Archway gyratory improvements for pedestrians and cyclists

Response to Consultation
March 2015

Published March 2015

Figure 1 Archway gyratory proposals

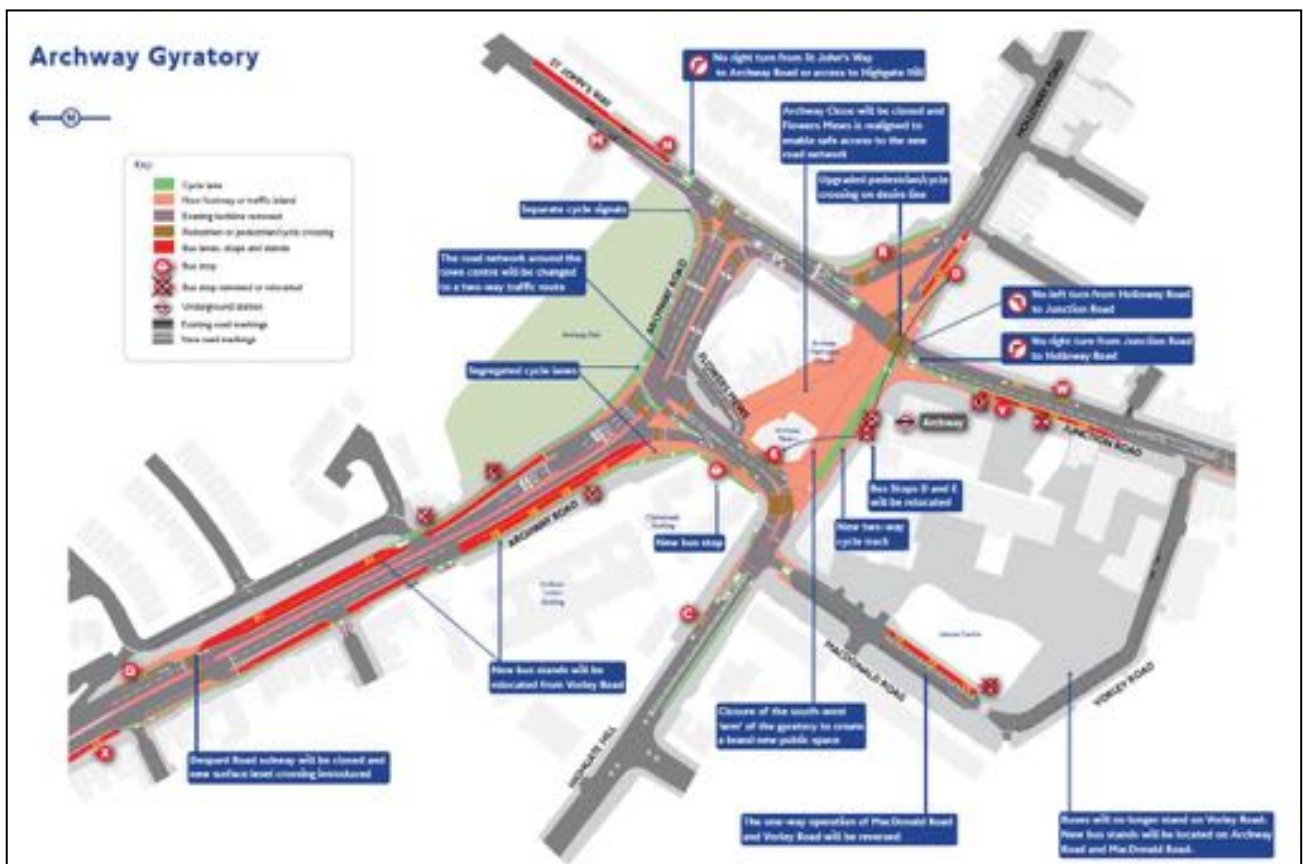
- 1.9 Some of key issues and themes from the individual and stakeholder responses include:
- The proposed banned turns, including any impact this may have on residential streets through displaced traffic finding new routes

- The relocation of bus stops and the resulting changes to bus services
 - Decreased junction capacity and increased journey times and congestion
 - The closure of Despard Road subway

- Pedestrian and cycling provision proposed by the scheme
- 1.10 Full details of all the consultation responses are available in Section 6 of this report (responses from the general public), Section 7 (responses from stakeholders) and Appendix E (responses to questions 8&9). TfL's response to issues raised is included as Appendix I of this report.

- Addition of a segregated route for southbound cyclists from Highgate Hill to Johns Way following concerns of the left turn conflict for cyclists at the junction of

Tollhouse Way and Archway Road. To fully segregate the southbound route, the pedestrian crossings at the Archway Road and Tollhouse Way junction will be converted to shared toucan crossings for pedestrians and cyclists.

- Improving the northbound cycling provision when leaving the new public space with a new section of cycle track between the public space and the junction of MacDonald Road.
- In addition to the southbound cycle track, creating a northbound segregated cycle track from St Johns Way for cyclists travelling northbound to the junction of Tollhouse Way and Archway Road.
- Widening of footway outside the Girdlestone Nursery on Vorley Road.
